CUYAMA BASIN GROUNDWATER SUSTAINABILITY AGENCY STANDING ADVISORY COMMITTEE MEETING

AGENDA

April 25, 2024

DRAFT – Conceptual Map for Developing Water Budgets

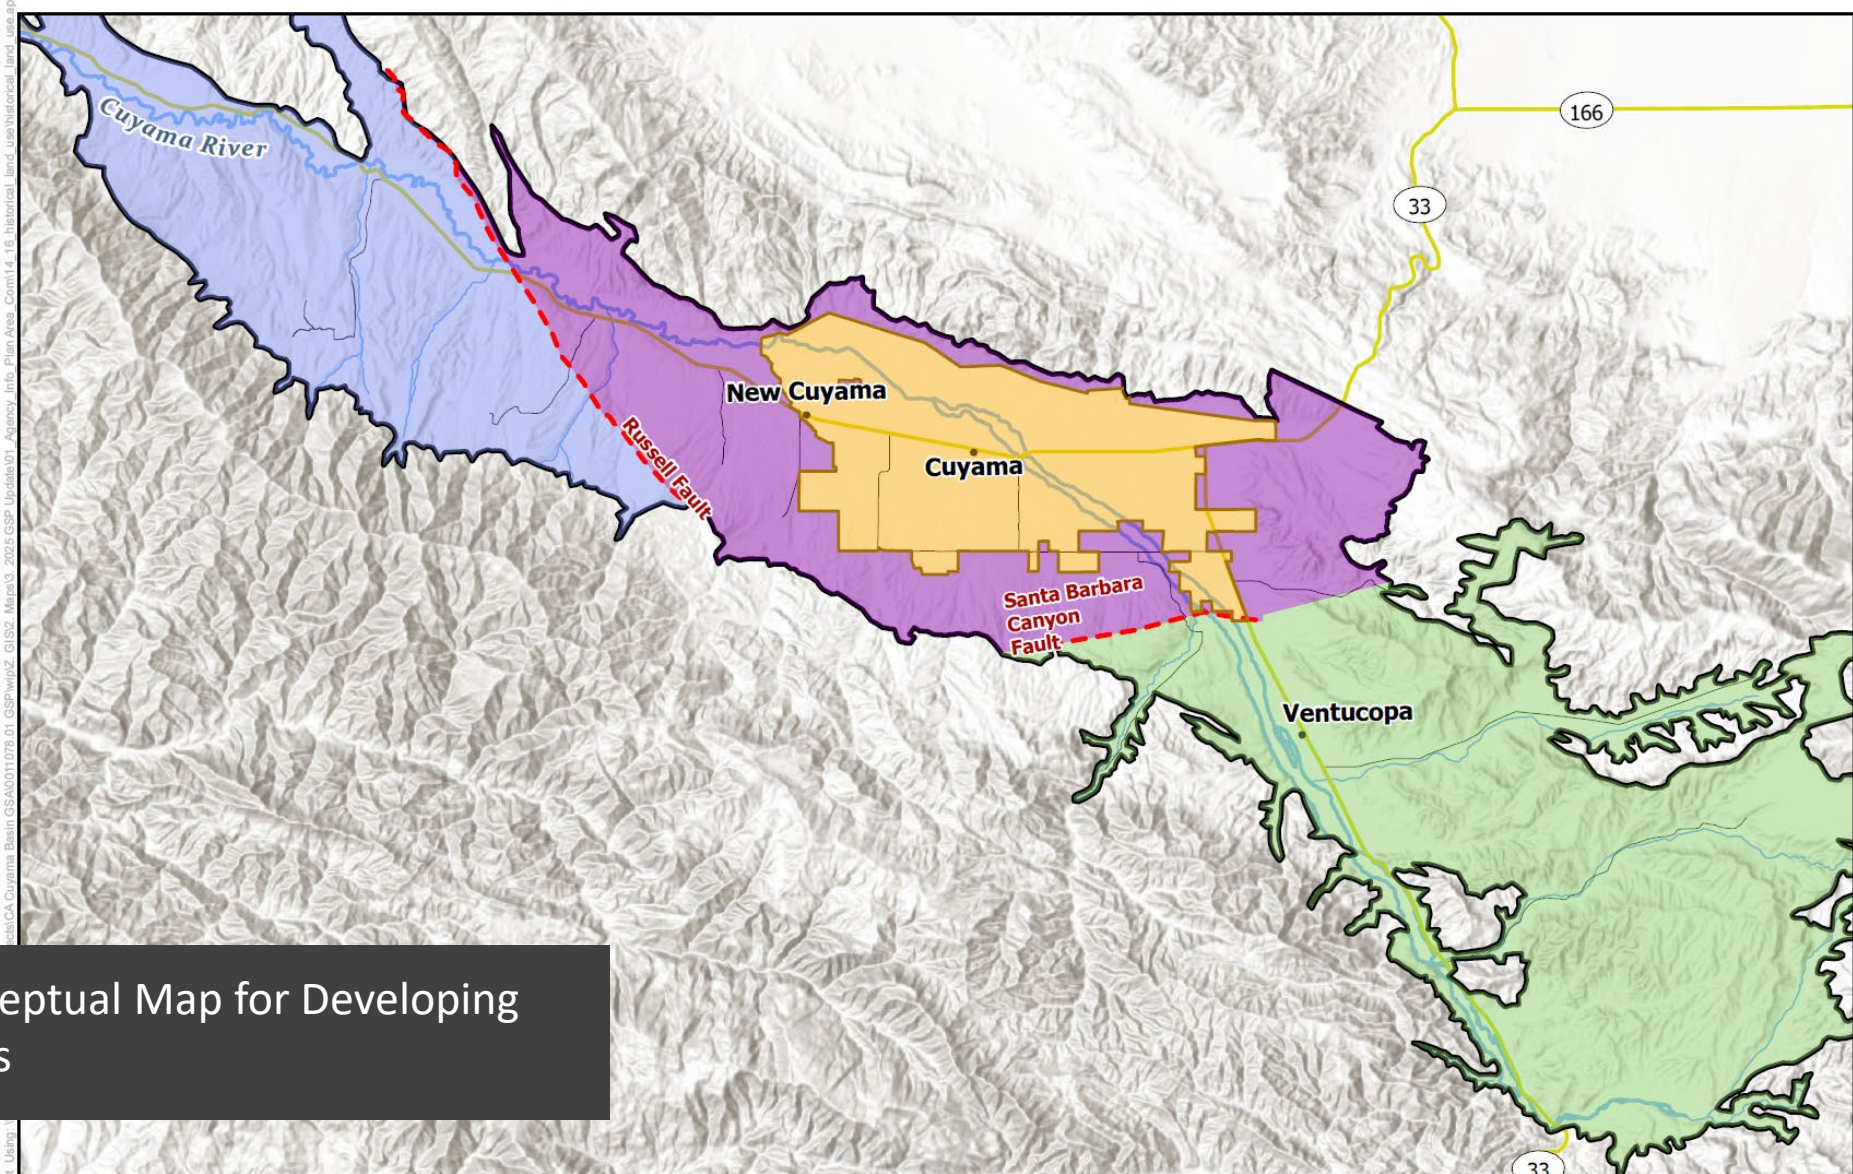
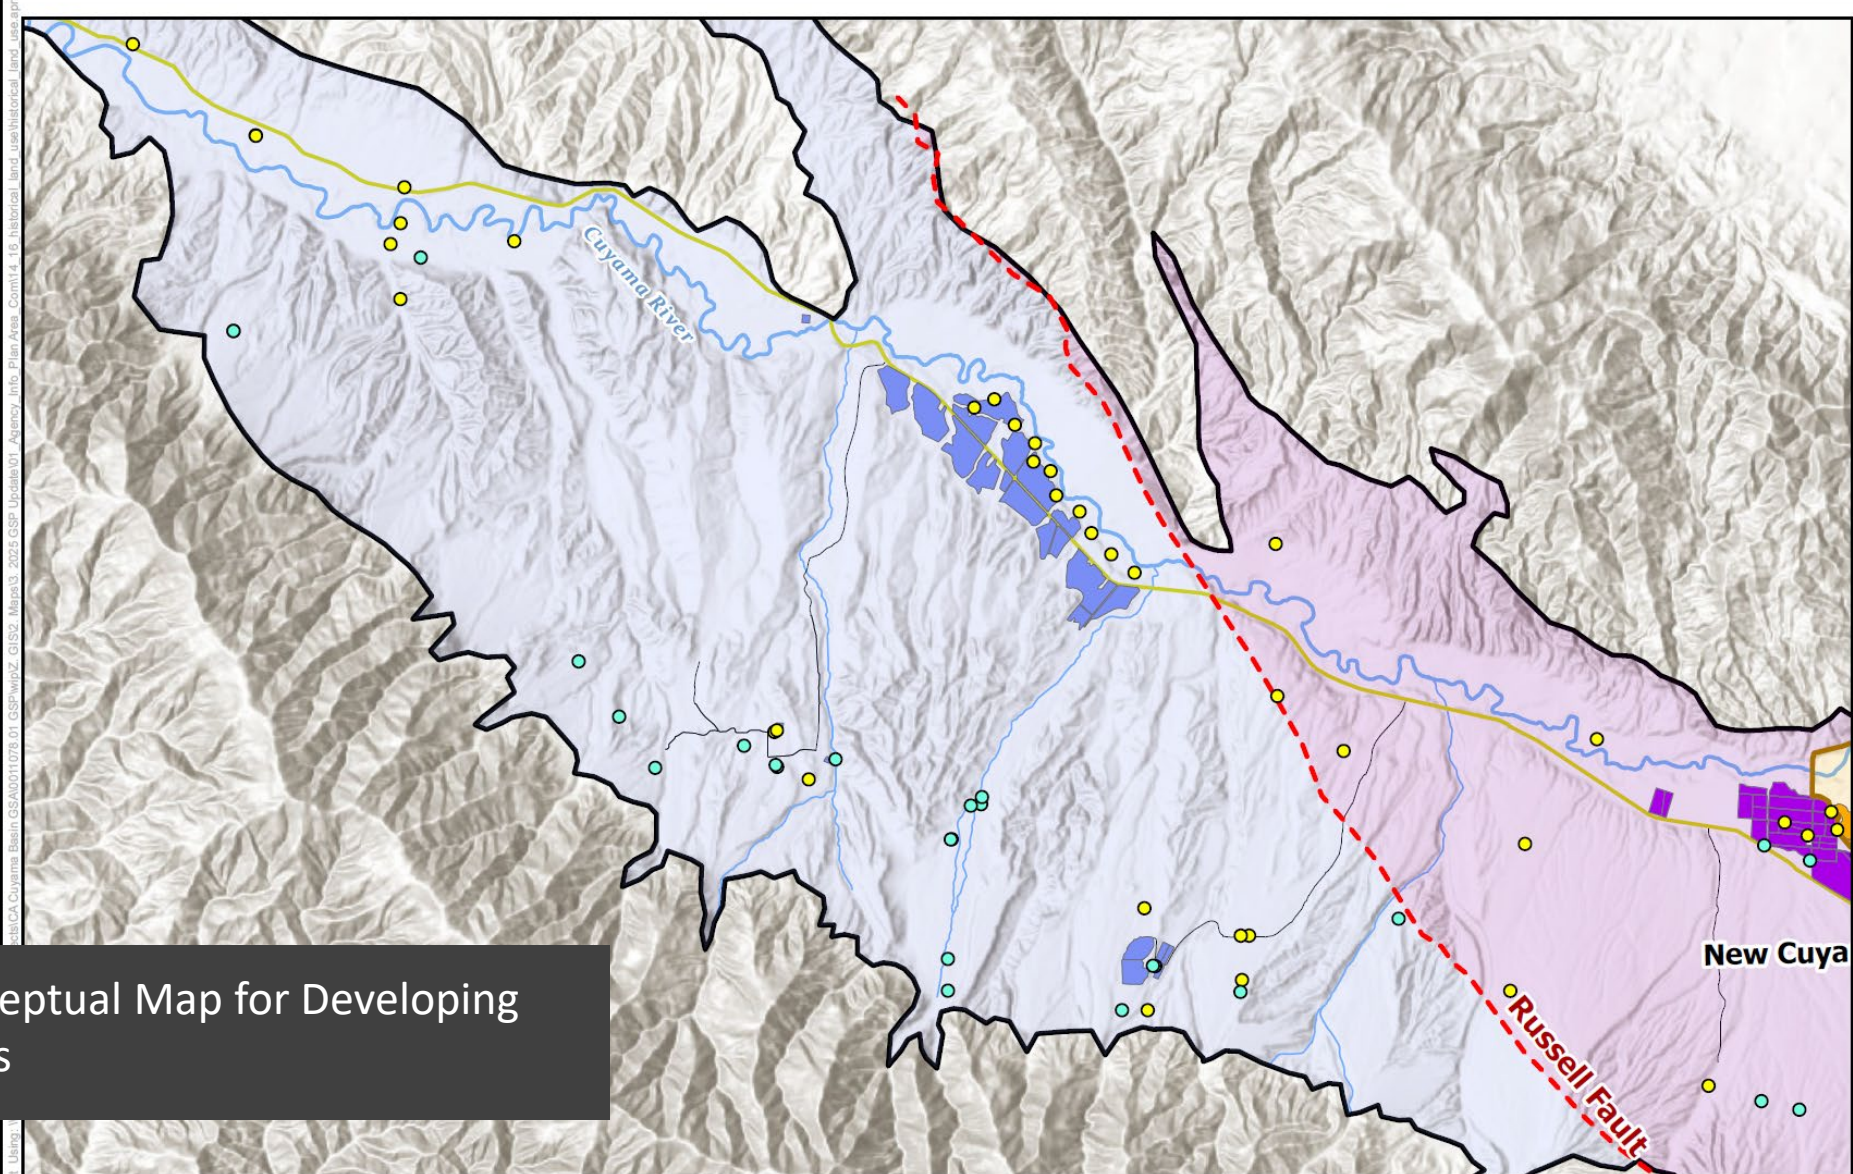
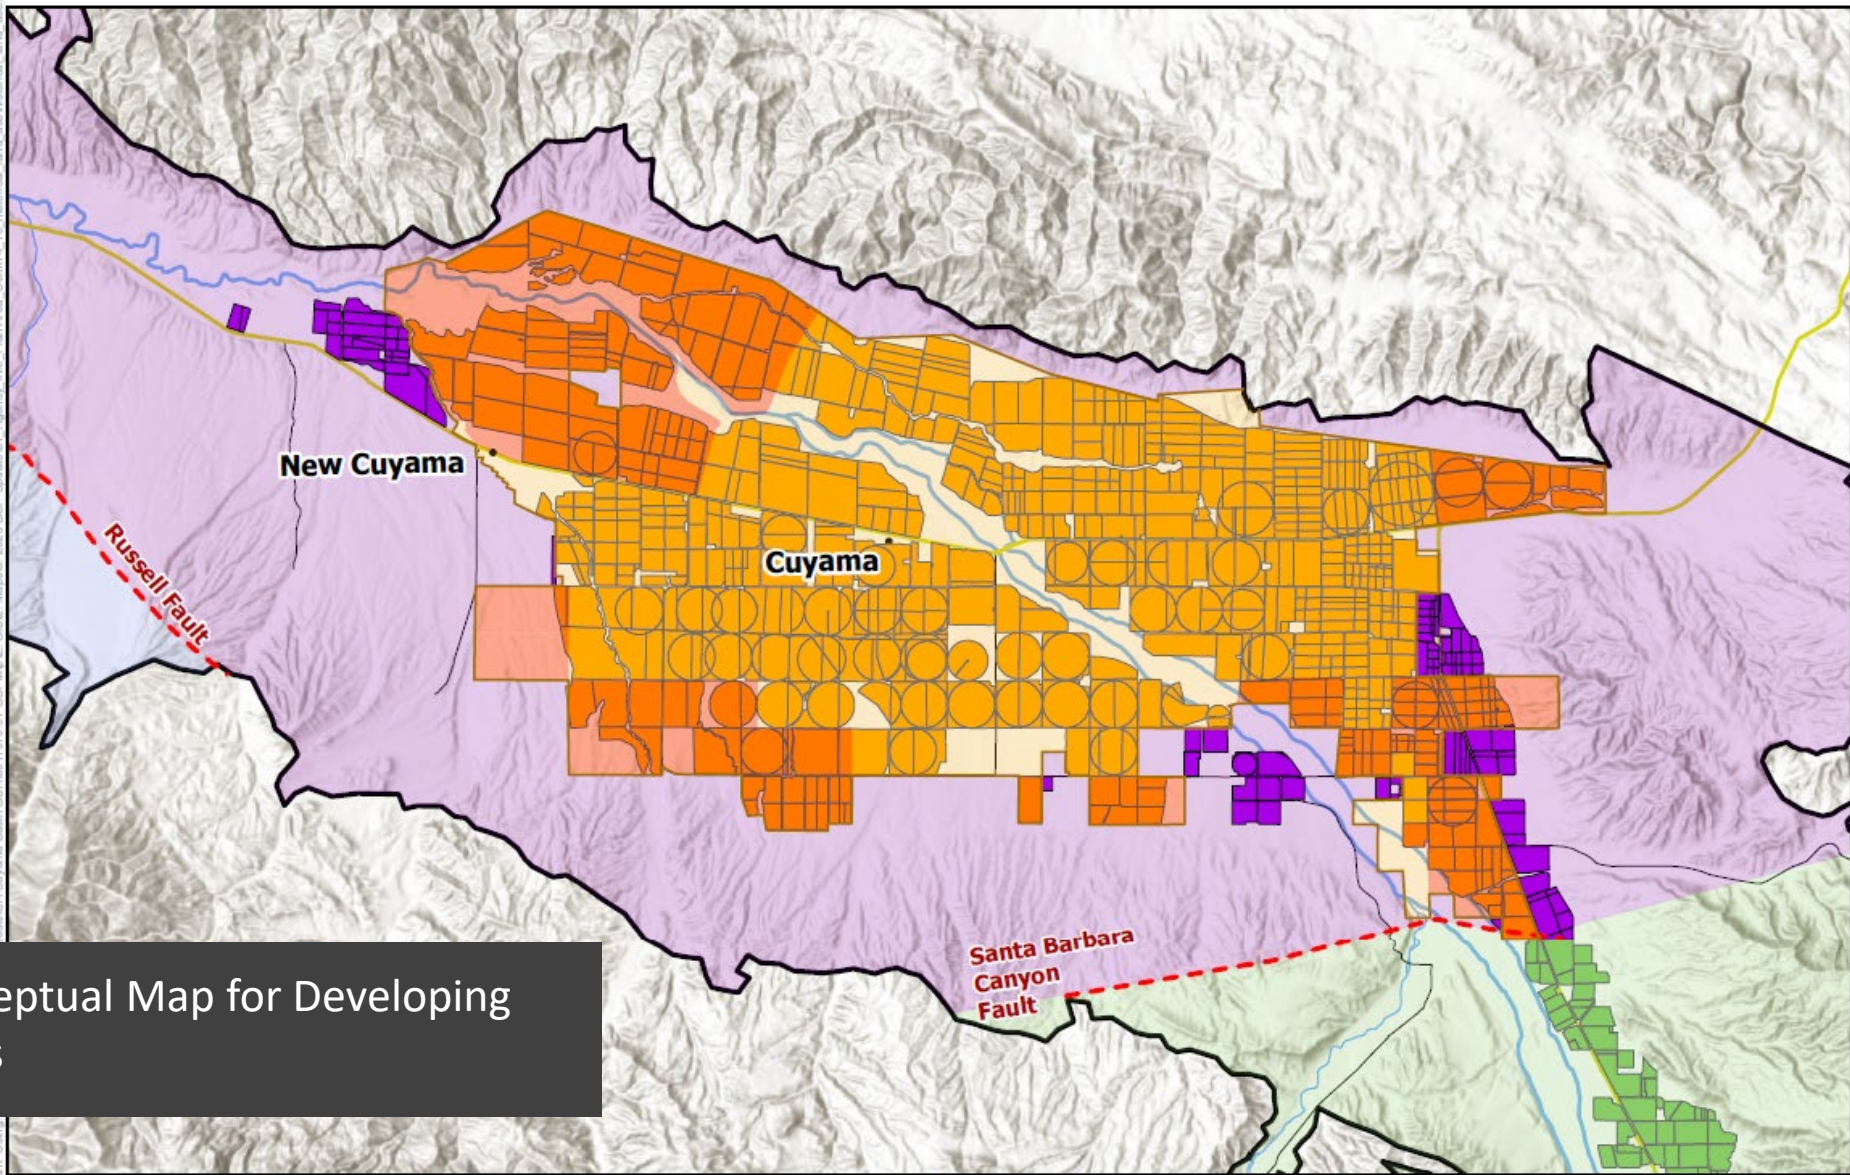
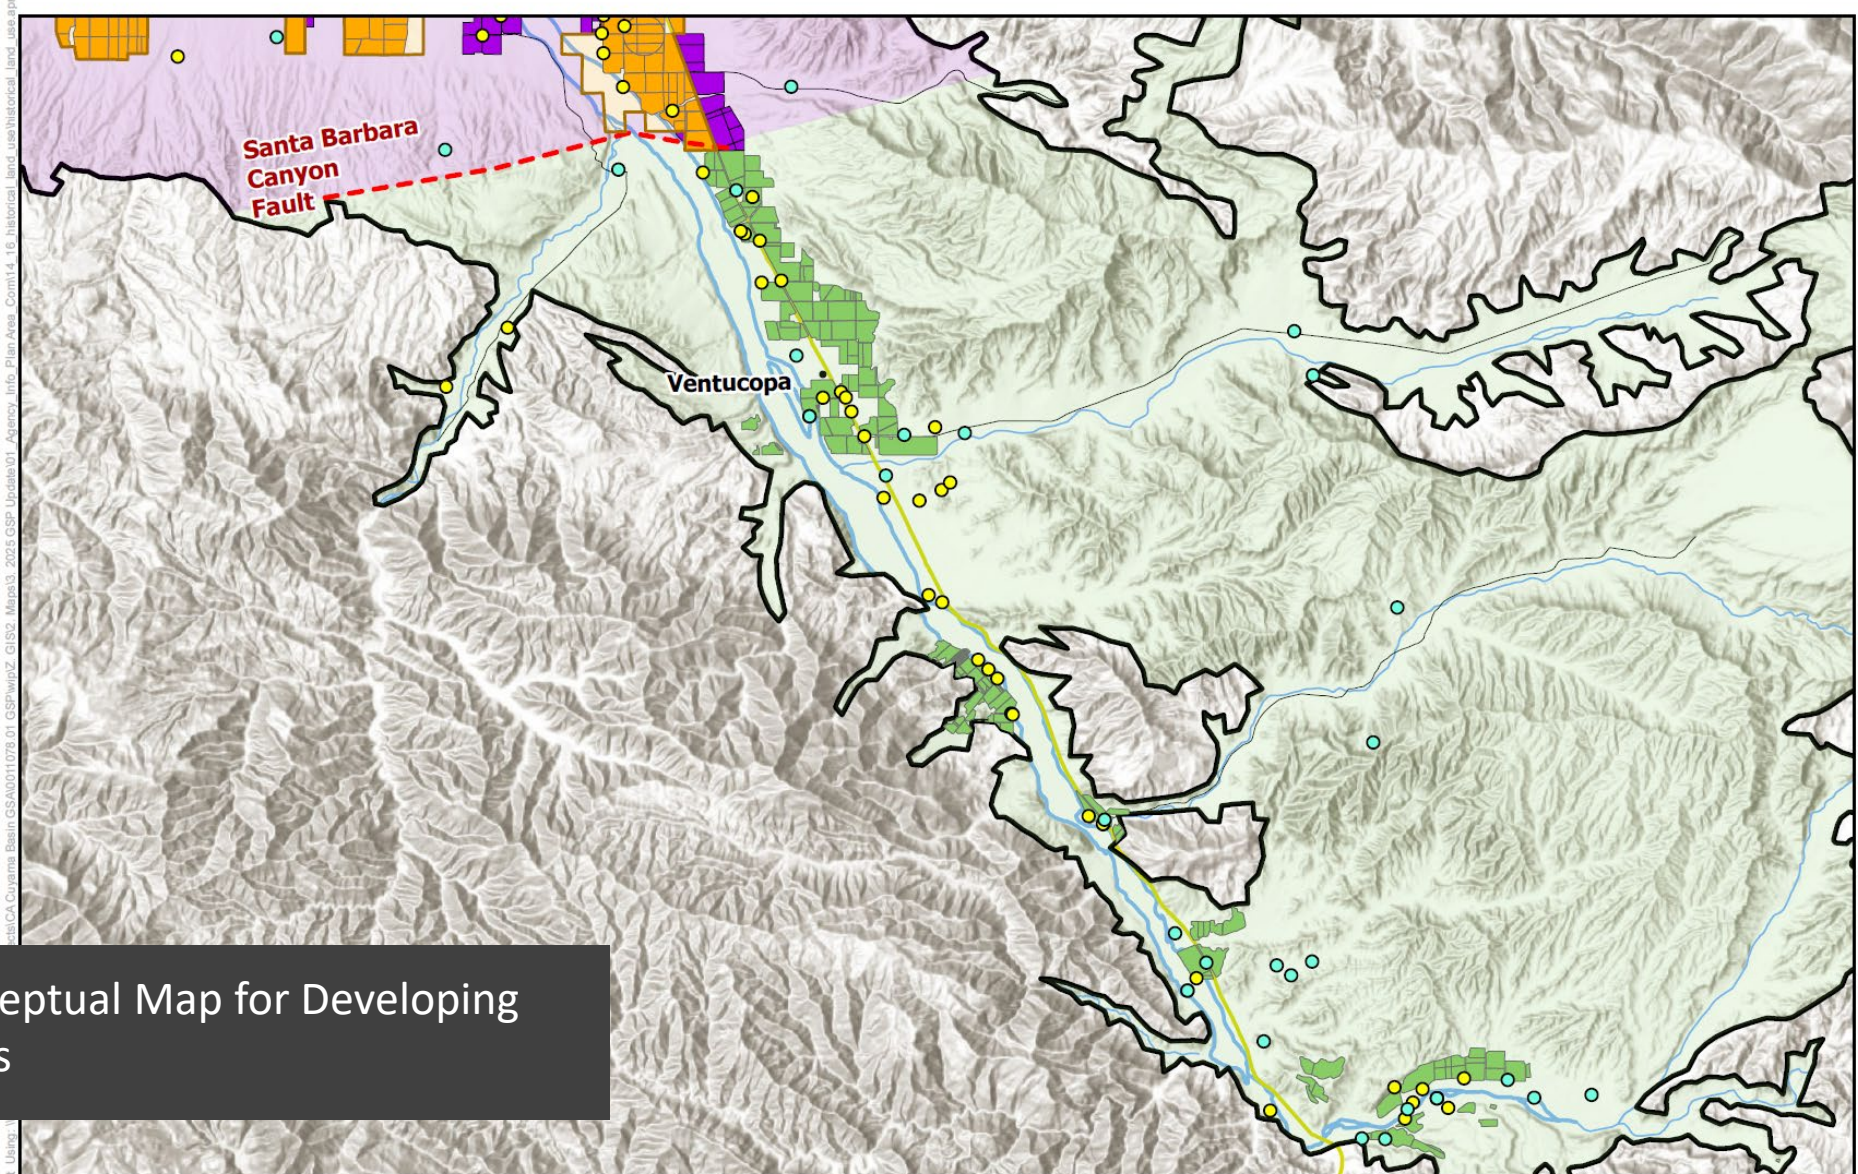
- Does the Technical Forum agree with using the Russell and Santa Barbara Canyon (SBC) faults as the physical features to subdivide the basin?

Comment by	Neil Currie, Cleath-Harris (Grapevine Capital)	Matt Young (Santa Barbara County Water Agency)	Bob Abrams, Aquilogic	Jeff Shaw, EKI (Cuyama Basin Water District)
Comment	Yes, but the mapped fault traces are a proxy/line on the map that represent more complex fault zones/fault barrier systems	Yes, in principle	Yes, but has questions on using the SBC fault based on recent geophysical survey results	Reasonable starting point; however, graveyard ridge fault and other faults may be significantly relevant
Staff Notes	NA	NA	NA	NA

Groundwater-Fault Interaction Investigation – Geophysical Surveys - SBC Fault

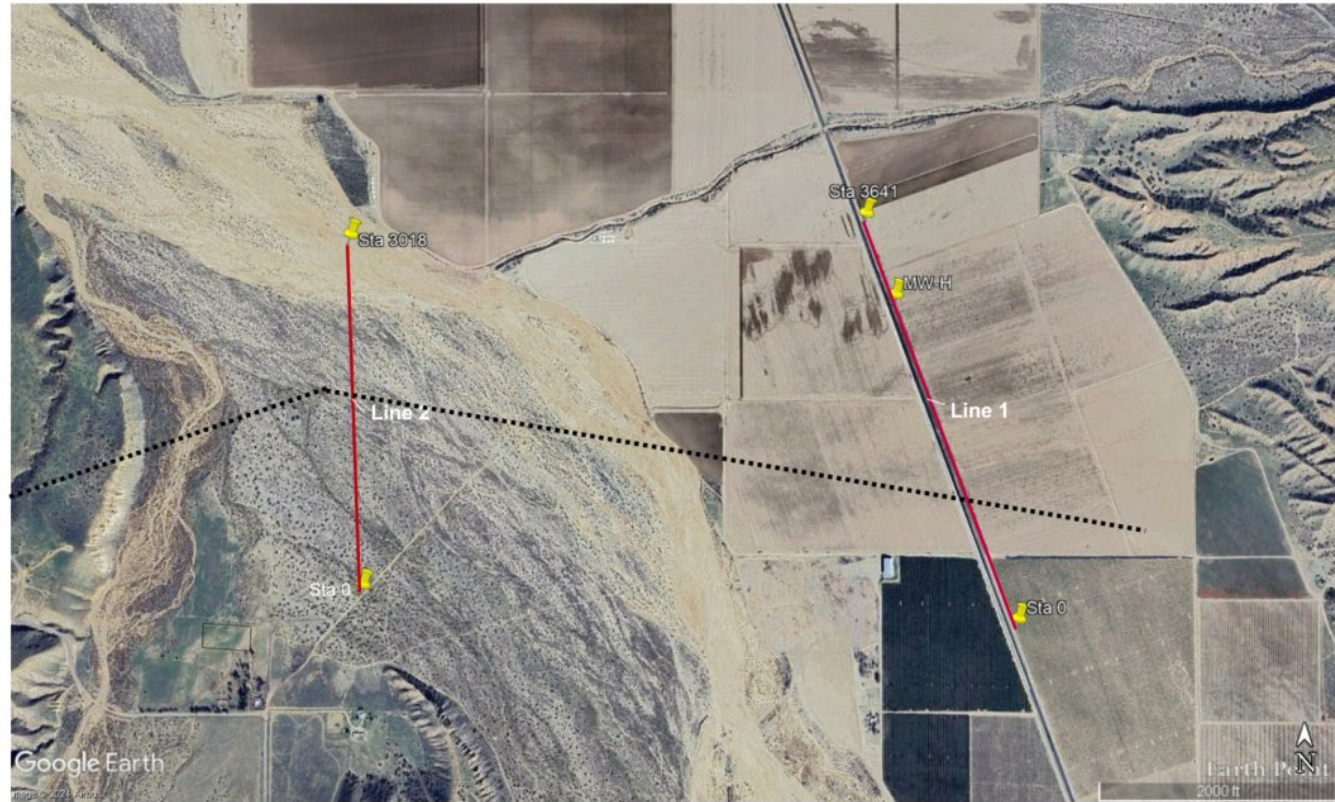
Comment by	Bob Abrams, Aquilogic
Comment	Will there be an additional investigation to further evaluate the Santa Barbara Canyon fault location?
Staff Notes	NA
